Safety Assessment of the Nuclear Power Plant Greifswald, Units 1 to 4

A Documentation of Hitherto Existing Investigations
made by GRS

GRS-78 (February 1991)
ISBN 3 - 923875 - 28 - 2

FIRST INTERIM REPORT CONCERNING
THE SAFETY ASSESSMENT OF
THE GREIFSWALD NPP
UNITS 1 - 4

Fig. 2-4: Overview diagram of the electrical installation of the 440 MW-unit, North I-II.

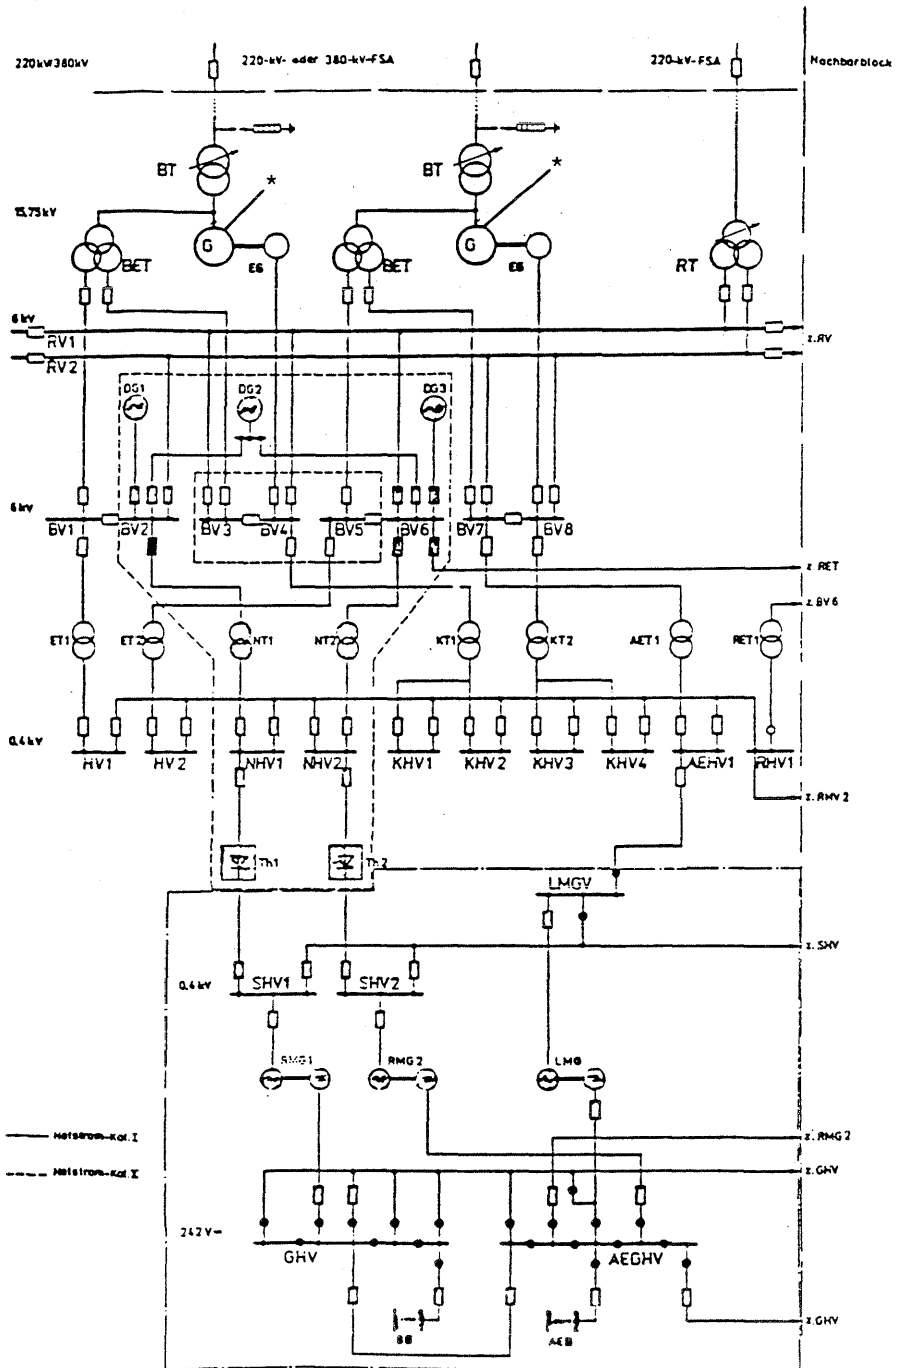
In figure 2-4, the positions of the switches for the conduct from the generator to the transformer of the unit should be indicated. For the given position, the rest energy of the main generator may not be utilised, what contradicts the concept of the project.

Fig. 3-3: Irradiation embrittlement of weld material for an environmental temperature of 270°C

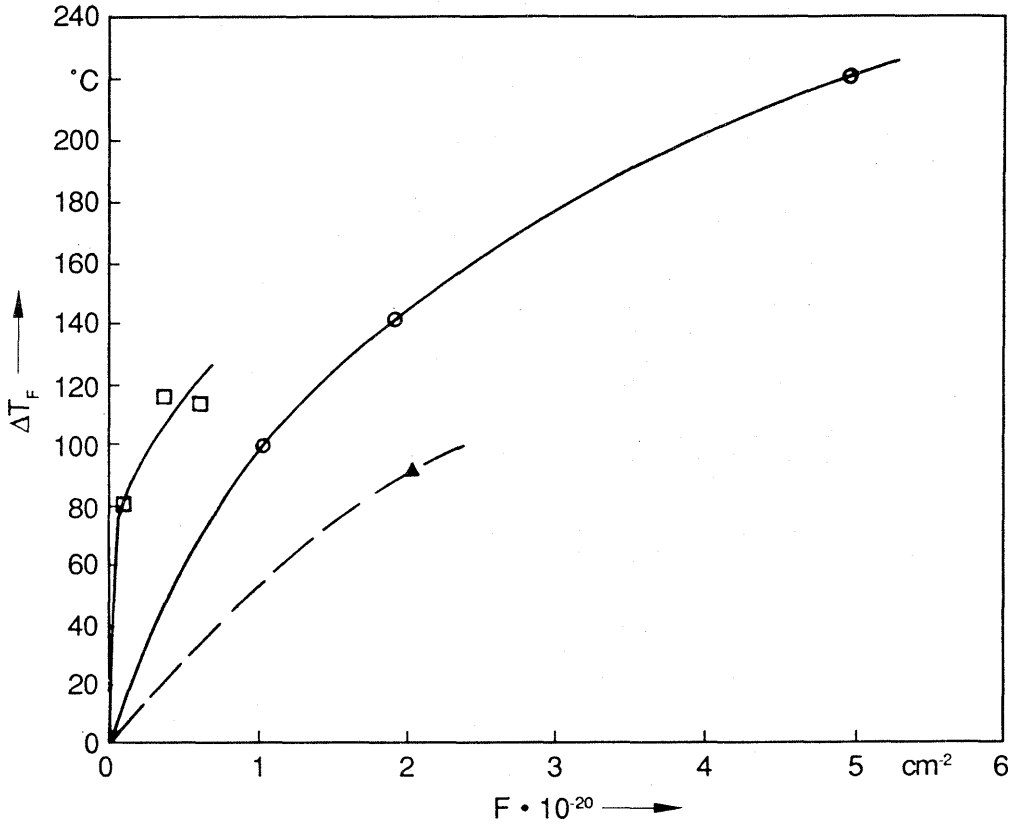
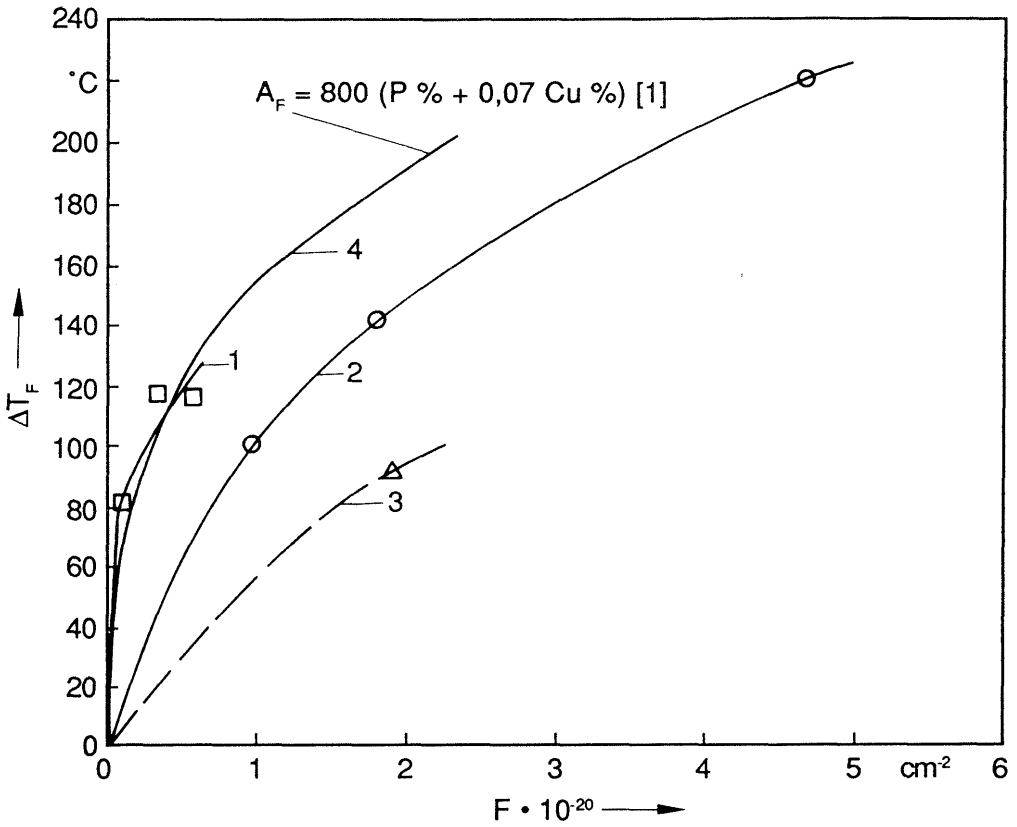
Figure 3-3 is to be replaced by figure 1 in the annex "Reason of the influence of the neutron flux density on the resistance against embrittlement."

Recently test results were obtained from samples which had been irradiated in unit 1 of NPP Rovensk with shielding boxes at reduced neutron flux density (cf. figure 1).

The figure shows a comparison of experimental values of T_F obtained for different fluxes to the curve obtained from equation 1. This curve was drawn corresponding to the real content of metallic phosphorus and copper, i.e. 0,028% P and 0,18% Cu.

From the figure we can see that the data obtained for the irradiation of samples with a flux density of about $1\cdot 10^{12} \text{ n}\cdot\text{cm}^{-2}\cdot\text{s}^{-1}$ are clearly below the normal dependence (1) and that the data obtained for the irradiation with fluxes of about $4\cdot 10^{11} \text{ n}\cdot\text{cm}^{-2}\cdot\text{s}^{-1}$ coincide with the normal curve. We have to remark, however, that experimental values of ΔT_F by 10°C are above the normal curve in two cases. This deviation is compatible with the uncertainty of the determination of the critical temperature of brittle fracture of steel.

Radiation embrittlement of weld metal material at an ambient temperature of 270°C and the calculated curve

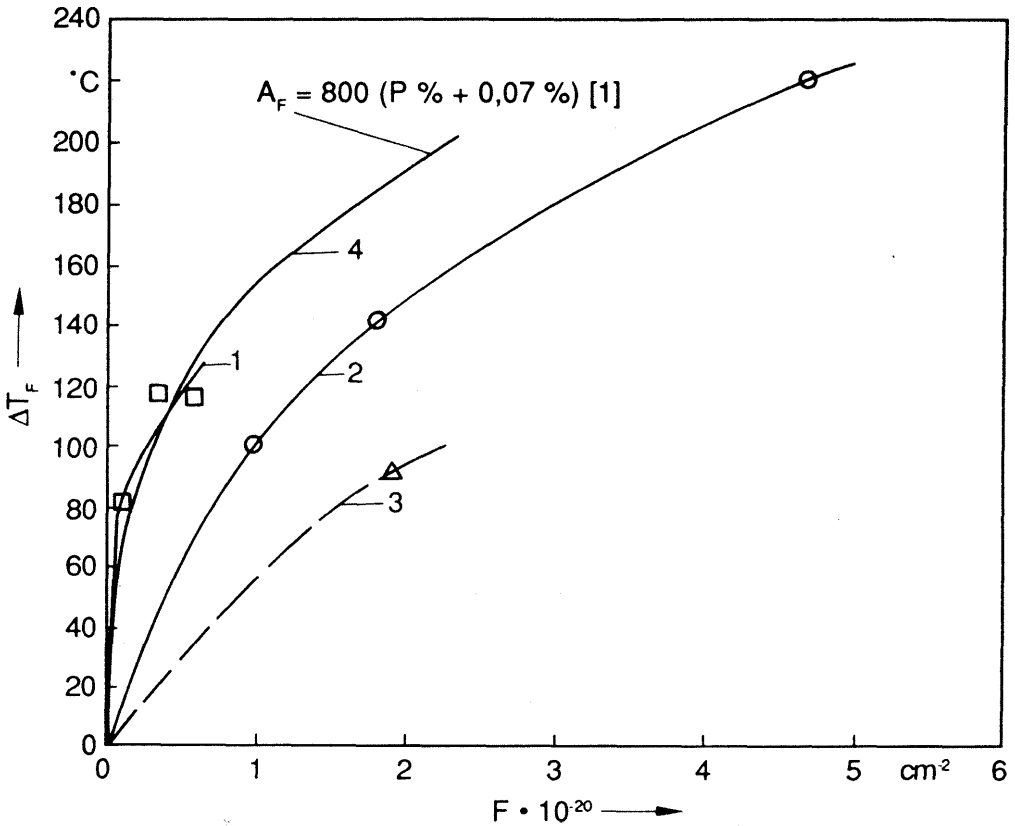
4. Fig. 4-7 should be replaced by Figure 1 from the "proposals and supplements" relating to the "First interim report on the safety assessment of the Greifswald nuclear power station" units 1-4 (WWR-440,W-230), Cologne, 15.2.90".
